INTERIM ADVICE NOTE LR&DP 009 – PARKING Amendment to DMM (Sept 2013)

Project: Local Roads and Drainage Programme

IAN#: PMC-IAN-DES-009

Appendix A: Amendment to DMM, Section 10

Figure 10-1: Typical Parking Set-backs for Local Roads

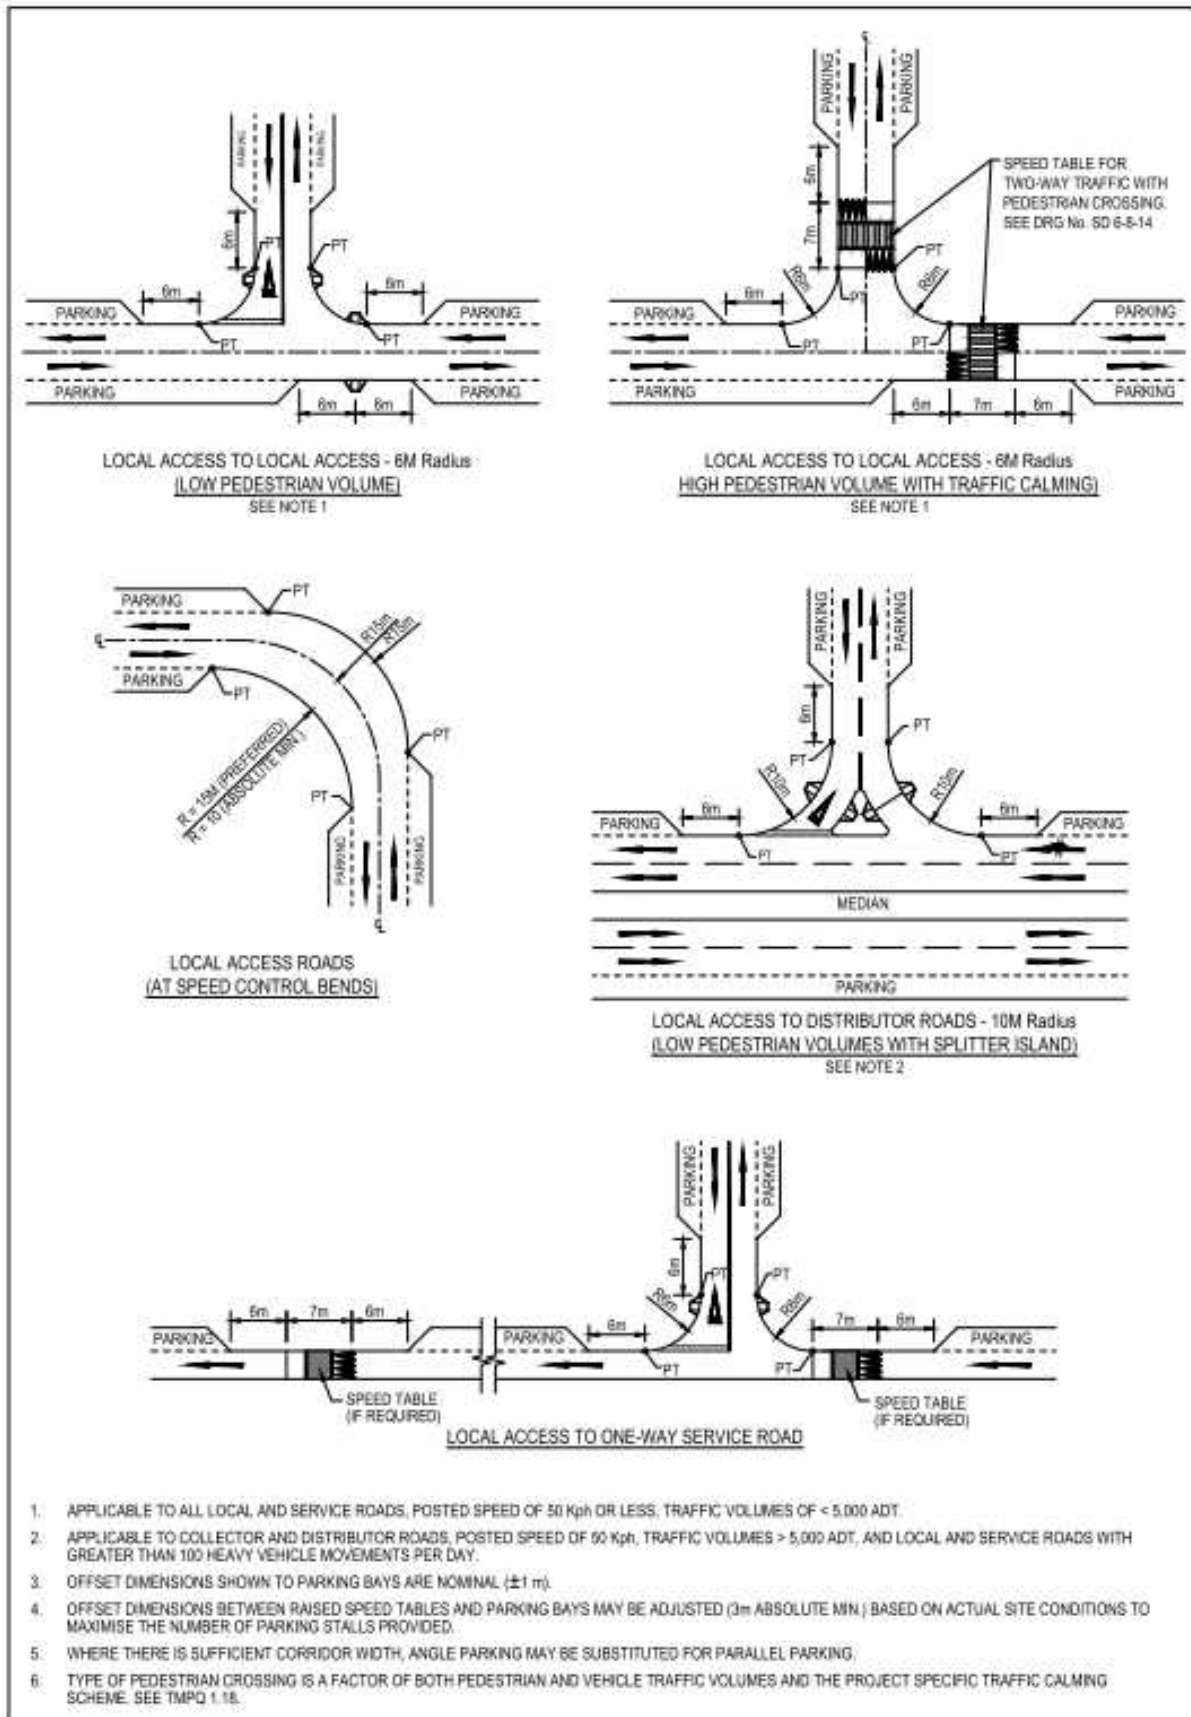
Consistent with AASHTO Section 4.20 – *On-Street Parking* and the TMPQ guidelines, on local roads, on-street parking should not be provided within a nominal 6 m of the tangent point of any intersection. See Figure 10-1 for setback locations of parking bays, based on the 6m nominal dimension.

On-street parking may be provided opposite the minor leg of a T-junction in accordance with the following conditions (refer to Figure 10-1):

- The junction is not signalized.
- Posted speed limits on both streets are less than 80 kph.
- Combined traffic volume is low, i.e. less than 5,000 ADT.
- Kerbed build-out(s) is provided to physically define/delineate pedestrian and bicycle crossings and parking should not be provided within 6m of the crossing.
- The junction is not located on a curve in which provision of the parking through the junction would adversely impact sight distance along the curve (see Speed Control Bend on Figure 10-1).

Setbacks from intersections and driveways to angled parking are the same as indicated for on-street parallel parking (refer to Figures 10-1 and 10-3).
